ADDENDUM NO. 1
TO THE
DRAWINGS AND SPECIFICATIONS
FOR THE
Maxwell Street Sidewalk Project

Issued From: The City of Bloomington
Planning and Transportation Department
Post Office Box 100
401 North Morton Street, Suite #130
Bloomington, Indiana 47404

Issue Date: October 30, 2020

PROPOSED
 MAXWELL STREET SIDEWALK FROM
 SHORT STREET TO MILLER DRIVE
 BLOOMINGTON, INDIANA

title: LINE PR-1 PLAN & PROFILE

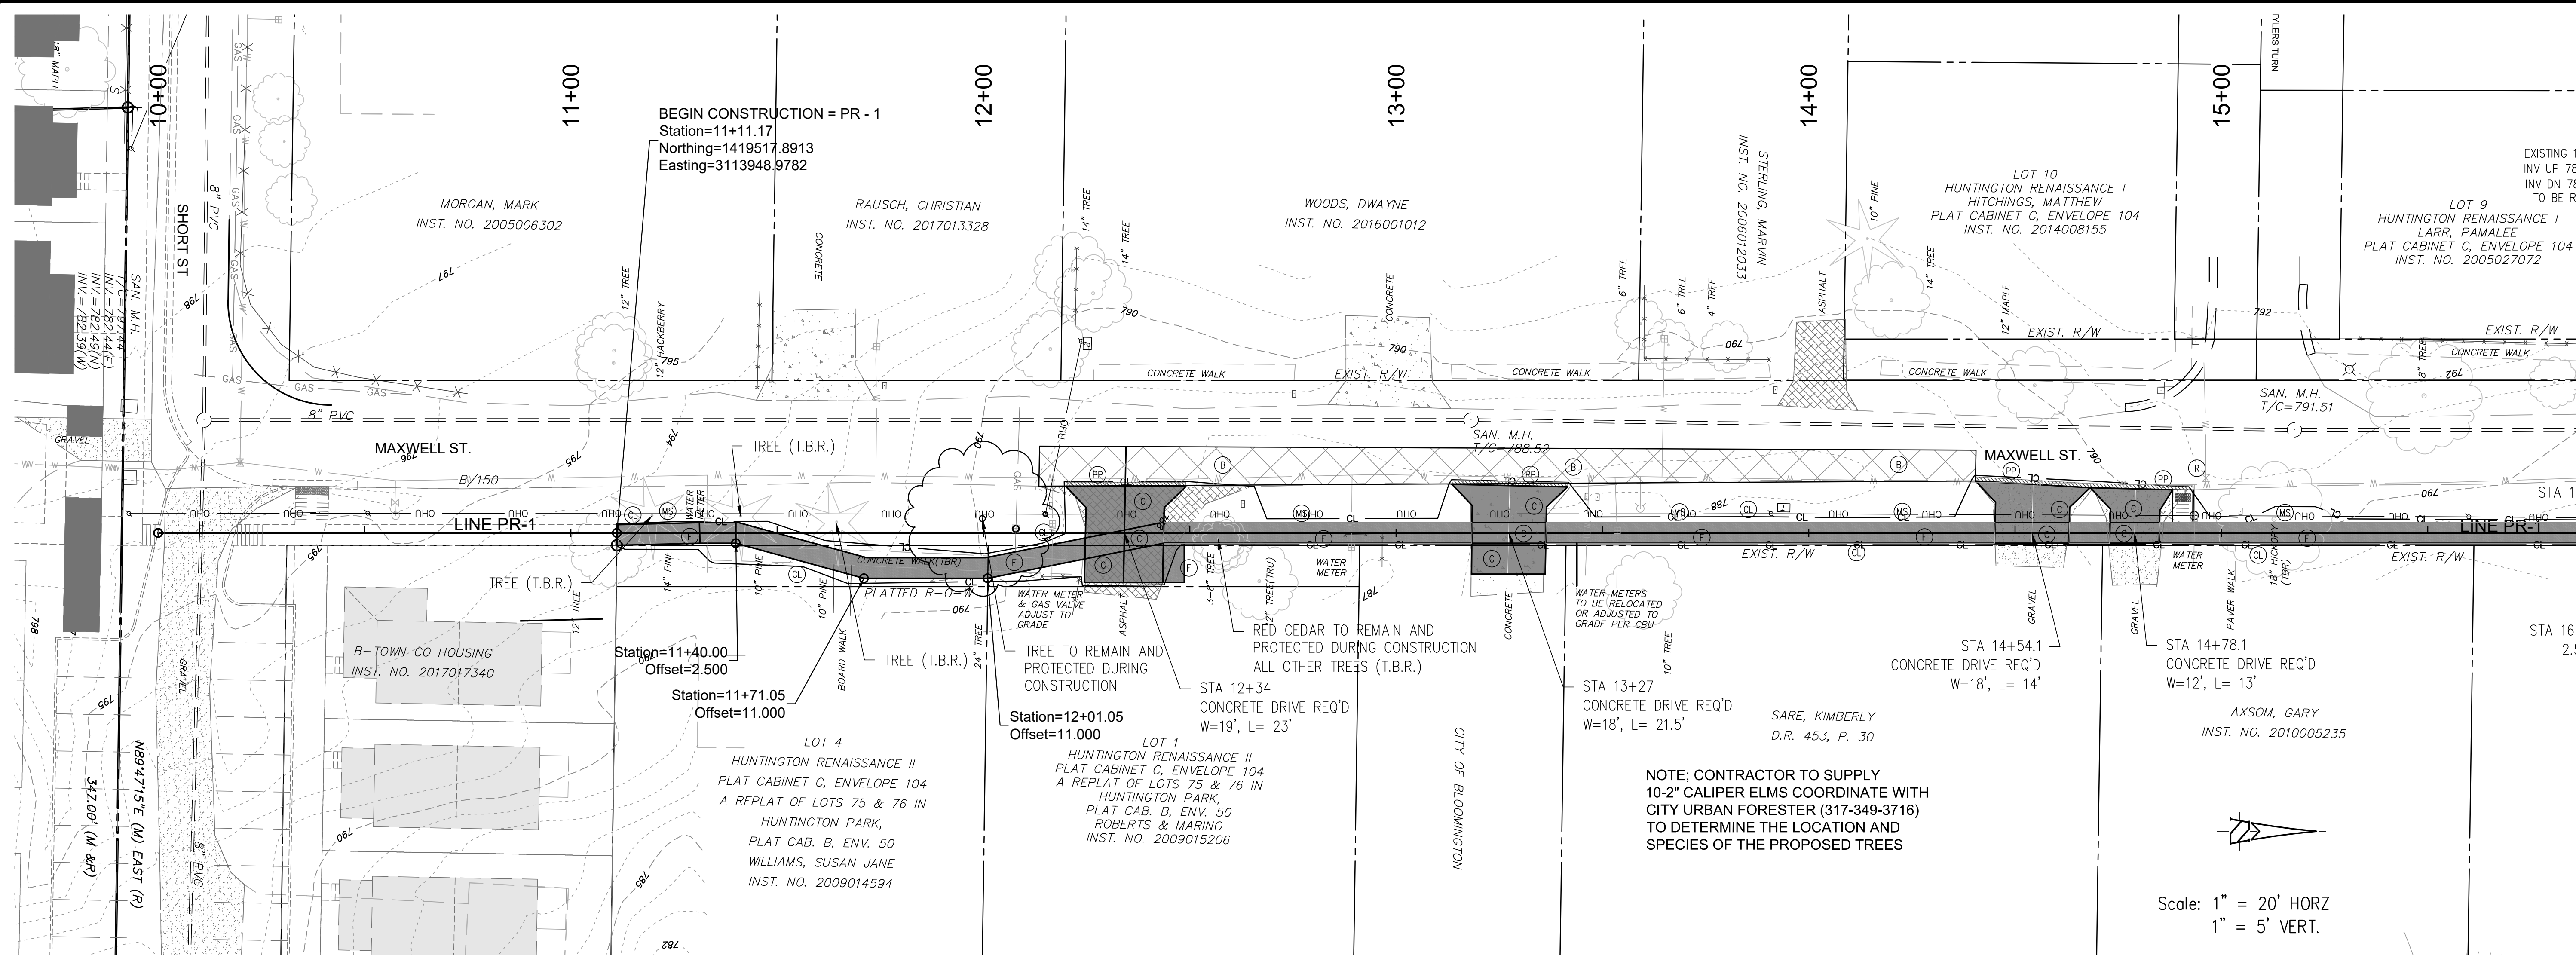
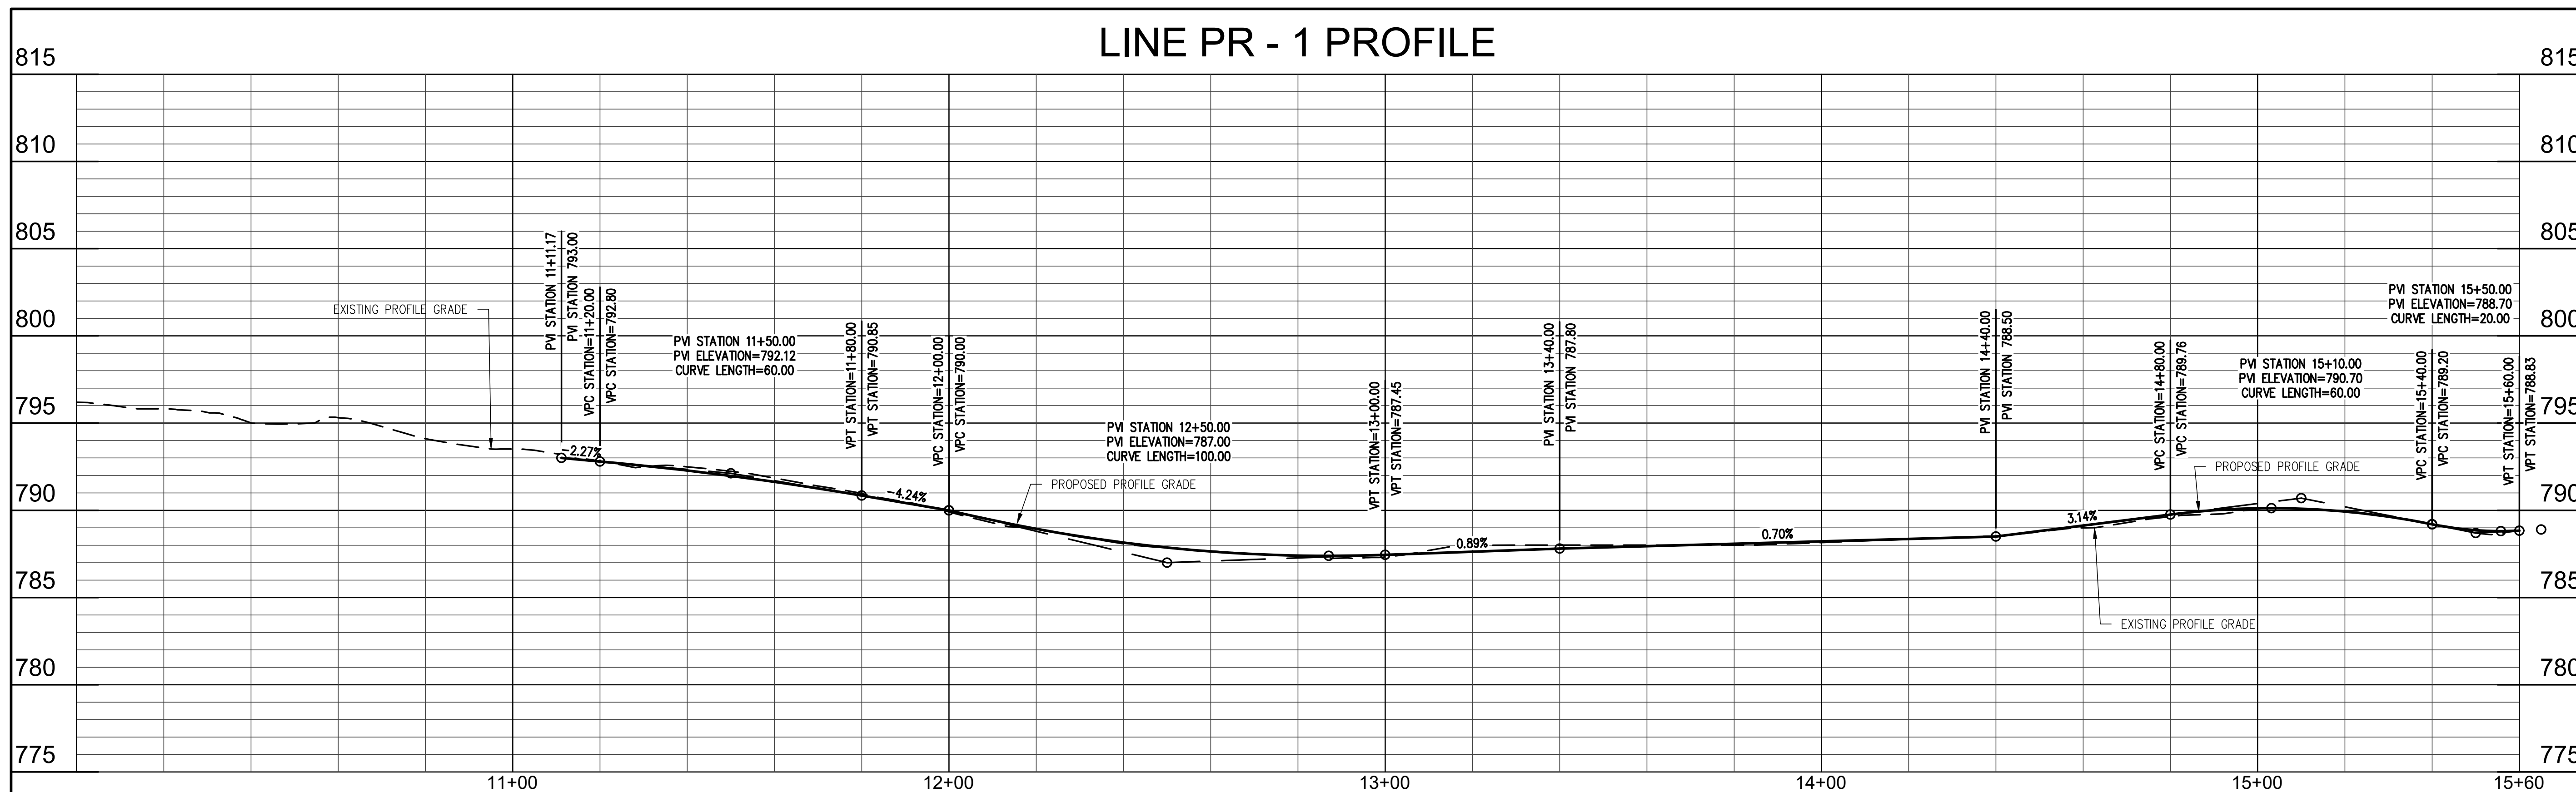
Item No. 1: A revised "Maxwell Street Sidewalk Plan and Profile" Sheet C301, has been issued and is attached to the addendum. The project shall be built as shown on the revised sheet.

- (A) For quoting purposes, all quoters shall assume that the water meters will need adjusted to grade only.
- (Q) There is an item for HMA Wedge and level for 18 tons. Where is this going to happen? I don't see anywhere in the plans where this is highlighted.

- (A) See the Corrected "Plan and Profile Page C301" included as part of this addendum.
